JULY 20, 2026 REGULAR MEETING

Administrative Coastal Development Permit No. 26-029 / 31810 Cottontail Lane

Planning Commission Meeting
07-20-26
Item 3.B.1.

31810 COTTONTAIL LANE (ACDP 26-029)
MALIBU, CA 90265

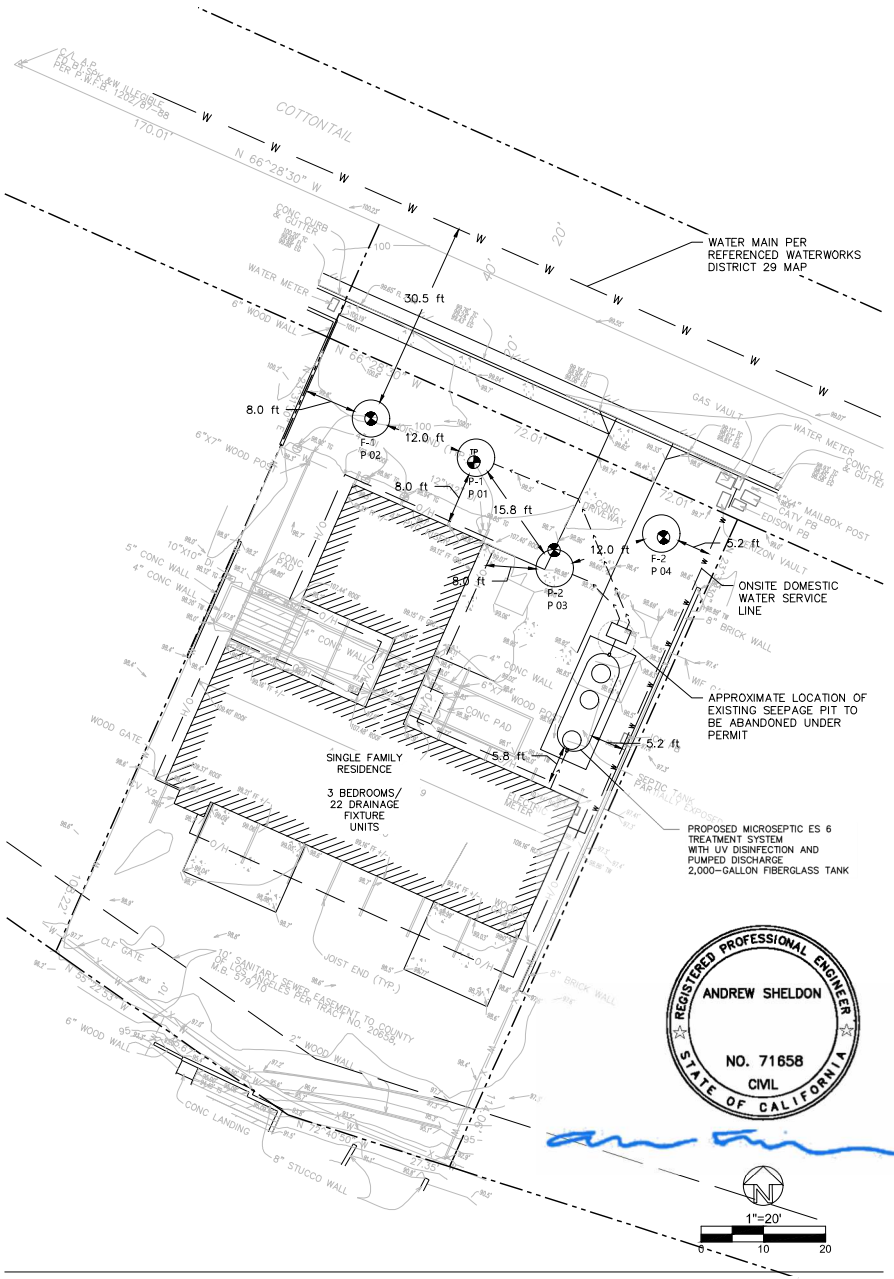
24. Proposed OWTS Component Reconfiguration to Maintain Minimum Required Setbacks: The Sheldon Engineering OWTS plot plan dated 3-27-2025 depicts proposed future expansion seepage pits that do not appear to meet the minimum required setbacks from the existing single-family dwelling and neighboring property line per the MMC.

a. Please revise the final OWTS plot plan to shift the OWTS future expansion seepage pits so that all minimum required setbacks are maintained or provide reduction in setback letters from the OWTS and Geotechnical consultants pertaining to the future expansion seepage pit (P 02) located near the existing residence. An additional Environmental Health review fee of $949 is required for reductions in setbacks. The proposed future expansion seepage pit (P 04) located near the neighboring property line must be shifted to maintain all required setbacks per the MMC - no reduction in setback will be approved for this pit.

30. Proposed OWTS Components in Vehicular Traffic Areas: The proposed treatment tanka nd proposed seepage pit may potentially be in a vehicular traffic area. Please indicate on the OWTS plot plan whether the proposed treatment tank and/or seepage pit will be in a vehicular area and provide call outs on the plan to protect the proposed OWTS as appropriate.
